File Code: 2720; 1900
Date: July 30, 2015

The Forest Service appreciates the opportunity to review the draft resource reports filed by Atlantic Coast Pipeline, LLC for the proposed Atlantic Coast Pipeline Project (Docket No. PF15-6-000). The proposed project would affect National Forest System (NFS) lands on the George Washington National Forest and the Monongahela National Forest.

**Comments of the U.S. Forest Service
Atlantic Coast Pipeline Project No. PF15-6-000
Draft Resource Reports**

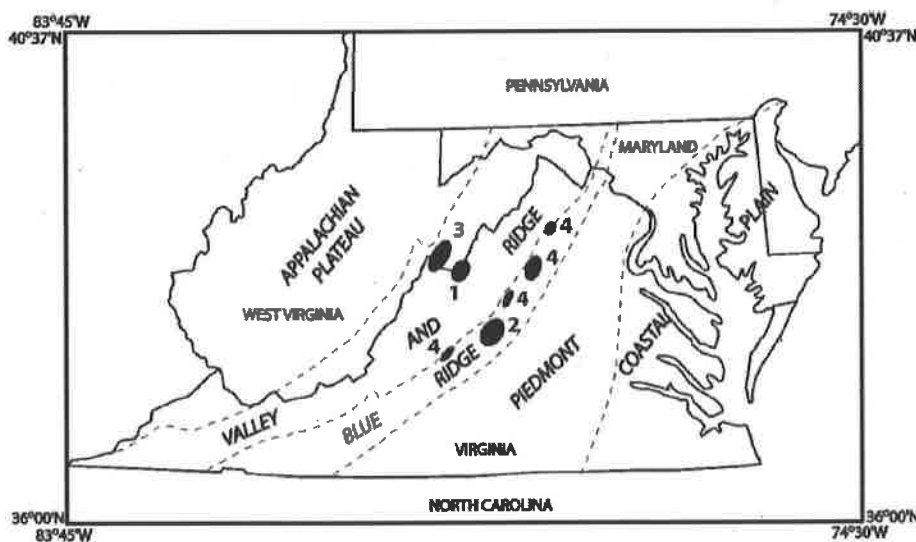
155. Consider the frequency of debris flow events, including the major debris flow events in Virginia and West Virginia from 1949 to 1996 (Figure 1). Recognize that the ACP project is in the vicinity of these major debris flow events in Virginia and West Virginia from 1949 to 1996, and assess the potential for future debris flows events to occur on the part of the ACP project on the GWNF and MNF. Recognize that intense storms can occur in any hurricane season as well as outside the hurricane season.

Figure 2. Old Coal Mine/Strip Workings on the Monongahela National Forest.

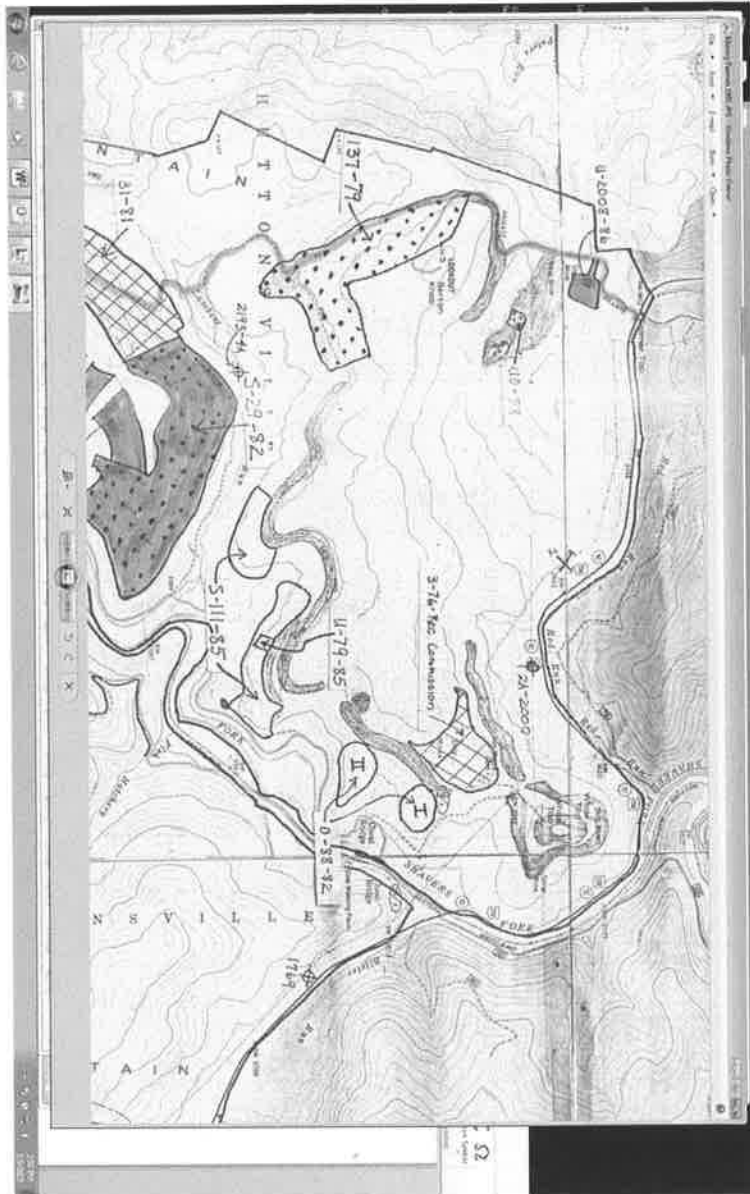
159. The map shown in Figure 2 illustrates the known locations of areas impacted by former mines and provides the history of the area that should be considered when collecting data, identifying effects, and conducting the analysis.

Figure 3. Role of debris flows in long-term landscape denudation in the central Appalachians of Virginia (Eaton et al. 2003).

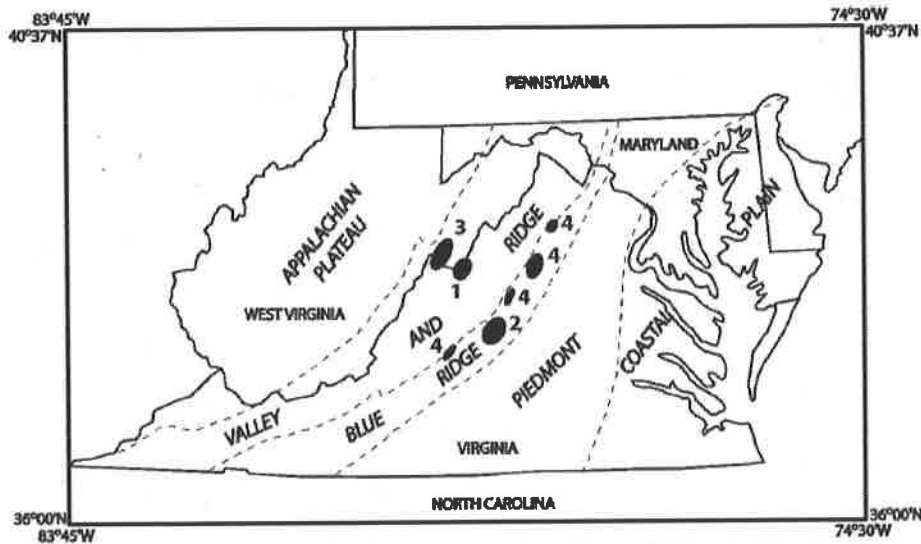
181. Assess the potential for debris flow type of landslides to impact the pipeline and associated facilities on GWNF and MNF. Consider the frequency of debris flow events, including the major debris flow events in Virginia and West Virginia from 1949 to 1996 (see Figure 3).

Figure 4. June 17-18, 1949 storm triggered more than 100 debris flows in the Little River area on the North River Ranger District in Augusta County, Virginia (Hack and Goodlett 1960).

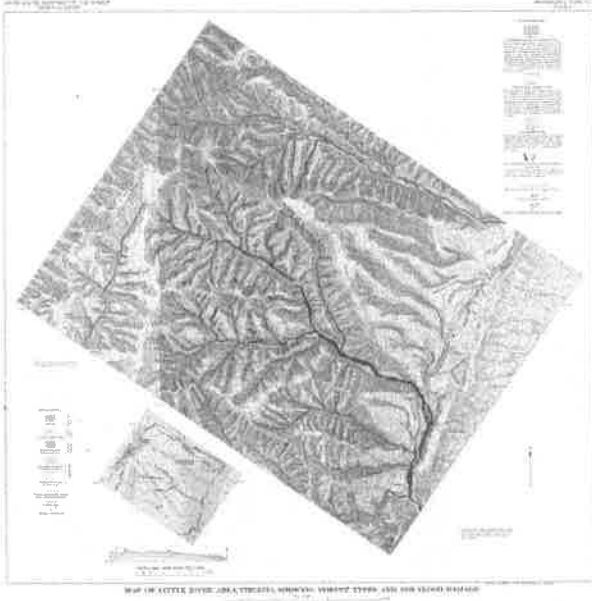
182. Assess the potential impacts on pipeline and access roads of swarms of debris flows, such as occurred in June 1949 in Augusta County (Figure 4) and in August 1969 in Nelson County (Figure 5).
